RE: RESPONSE TO SUBMISSIONS 2 - UNIVERSITY OF NEWCASTLE HONEYSUCKLE CITY CAMPUS DEVELOPMENT (SSD 9262)

Ethos Urban has prepared this letter on behalf of the University of Newcastle in response to your letter dated 27 September 2019 regarding the re-exhibition of the amended Concept Plan (SSD 9262) for the University's Honeysuckle City Campus Development (HCCD).

Figure 1 Extract of Public Domain Plan

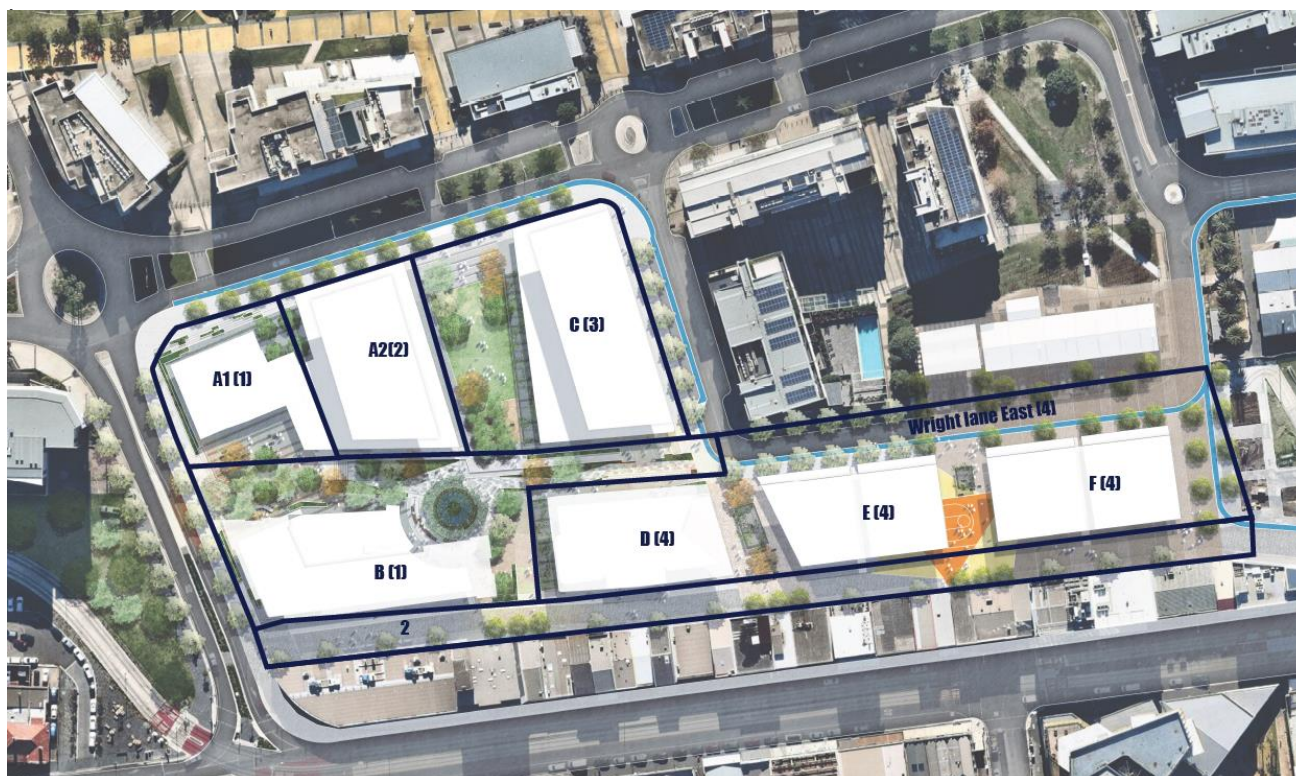
The Department has requested further detail within the public domain strategy to clearly identify the hierarchy of public domain spaces throughout the university campus and their intended function and character, including desired locations for activation, hard and soft landscaping, public art and water sensitive urban design strategies.

Oculus has prepared a Public Domain Strategy (**Attachment B**) to support the Cox Concept Masterplan which provides additional details on the proposed use and landscaping of the various areas of public domain across the campus. The strategy is informed by the surrounding site context and aims to reinterpret the bushland setting of the Callaghan campus to the west of the city, the harbour to the north, the cultural heritage to the east and urban grid of Newcastle to the south. It has been developed to provide an active ground plane that responds to a variety of site constraints and provide a diversity of spaces for the University staff and students, as well as the broader community.

The Public Domain Strategy includes a distinct hierarchy of spaces which reflect different uses throughout the day and into the evening. Some are associated with the ground floor uses of the buildings while others provide areas for passive recreation that cater for different sized groups. Other areas form transitional spaces for students and staff to pass through but still allow people to occupy and dwell. The Public Domain Strategy is focused around the following key spaces (refer to **Figure 1**):

Figure 4 Revised Civic Lane Section

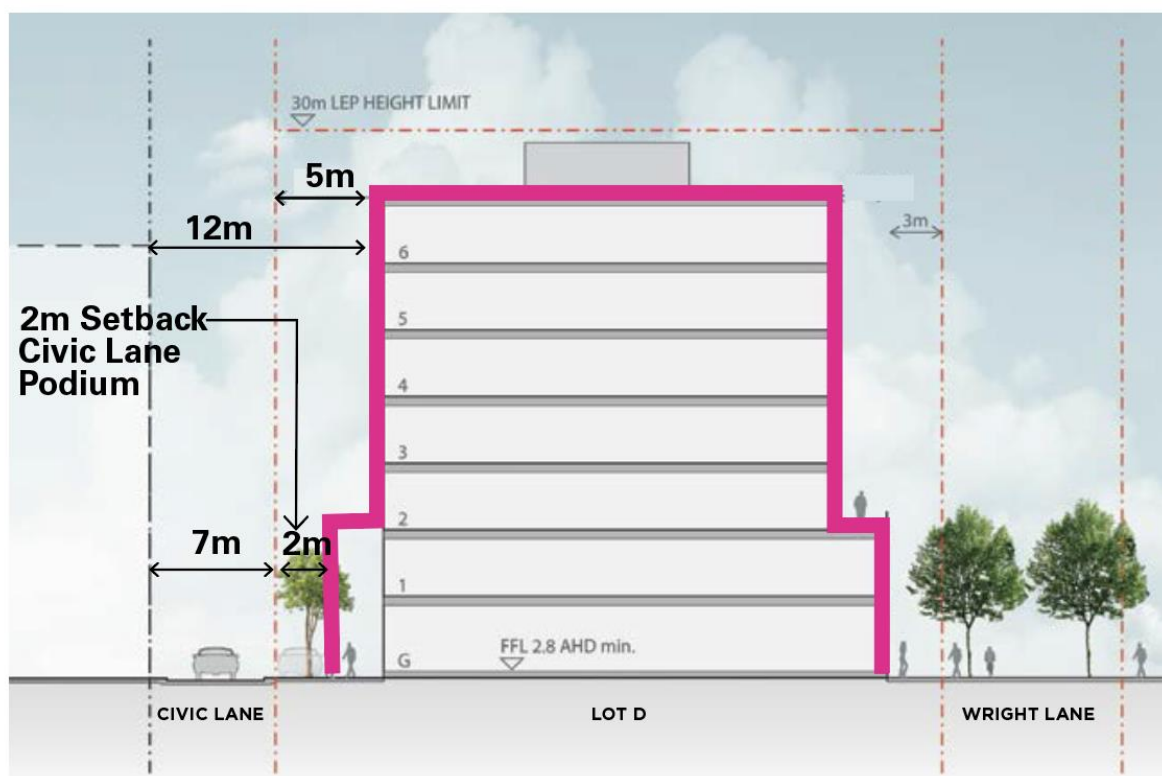
The Department has requested further consideration of refinements to the building envelopes to minimise amenity and heritage impacts as well as reconsideration of building efficiencies to provide flexibility within the envelopes to achieve design quality in future stages.

Notwithstanding the above, further design analysis has been undertaken by Cox and revised Design Guidelines have been prepared to improve this interface (refer to **Appendix E**). By increasing the setbacks and further opening the gaps between the proposed building envelopes above the podium levels, solar access can be improved to the neighbouring Civic Lane residential properties in the west. Across the precinct, the original podium planning has been reinforced and the following built form principles have been adopted (refer to **Figure 4**):

- Maintaining two storey podiums along Wright Lane and around Honeysuckle Green and the Turntable Plaza;
- Introducing new setbacks above a two storey podium on Honeysuckle Drive to better manage building scale and wind effects;
- Introducing a two storey podium setback 2m from the widened Civic Lane (which is 7m) on Lots B, D, E and F to improve the articulation and scale of buildings along this frontage and to increase the area and efficiency of education uses on lower levels of these buildings;
- The built form above the podium along Civic Lane will be setback 5m from the new Civic Lane boundary which maintains at least 12m separation to sites on the south of Civic Lane; and
- A new 3m setback above the two storey podium on buildings along Civic Lane (Lots B, D, E and F) improves solar access to buildings south of Civic Lane.

Figure 7 SHR Curtilage and Concept Plan

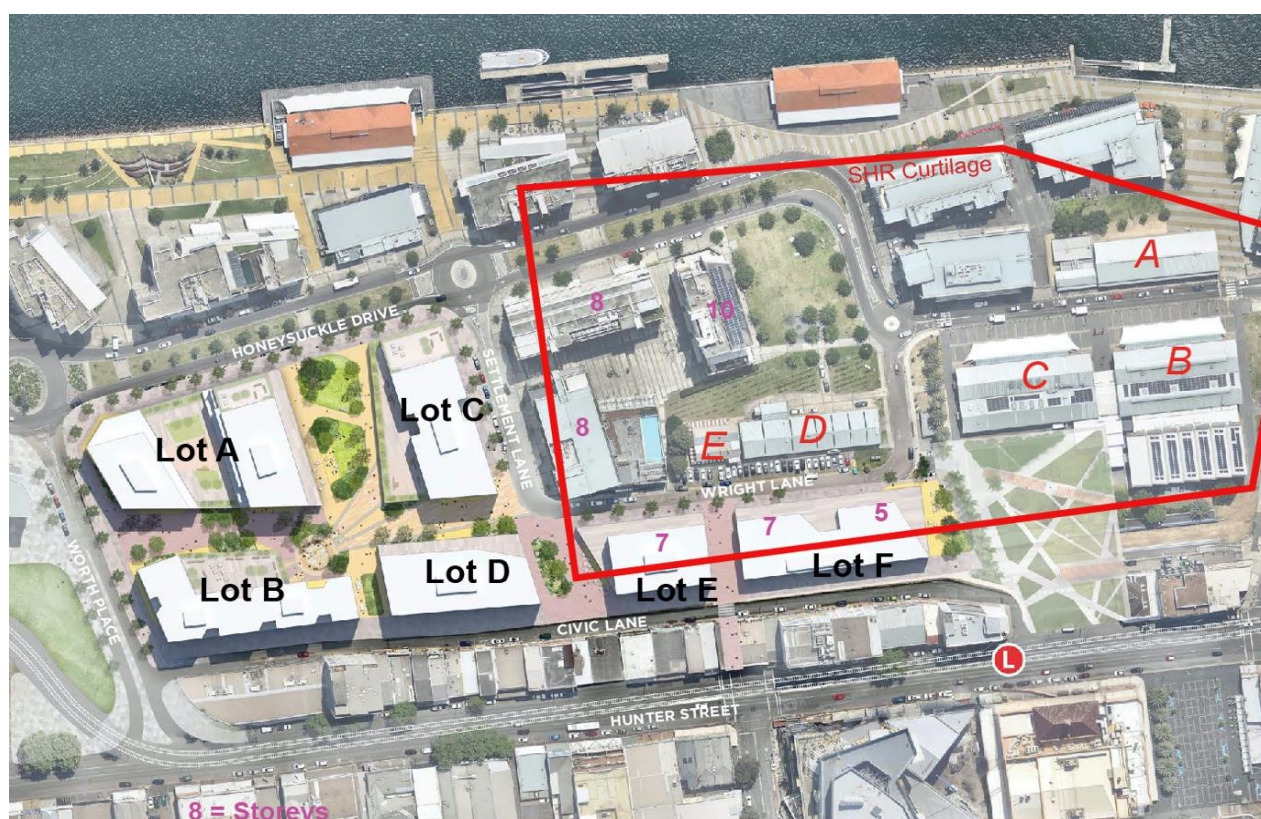
The Heritage Council has recommended that the Concept Plan be revised to remove the proposed intrusion into the SHR curtilage to avoid the visual impact and impact on the setting of the Civic Railway Workshops.

Removing the proposed built form from the SHR curtilage would effectively result in the loss of Buildings E and F. This would be an unacceptable outcome for the University and would jeopardise the achievement of core objectives from State and local planning strategies which rely on the delivery of an expanded University campus in this location. The removal of the buildings from the SHR curtilage is also considered unnecessary in context of the existing surrounding built form and the opportunities for the proposed HCCD buildings and public domain to better respond to the Civic Railway Workshops Group.

Future development applications for the detailed design of Buildings E and F, and any associated public domain, should demonstrate how the built form appropriately responds to the heritage curtilage of the Civic Railways Workshop Group.
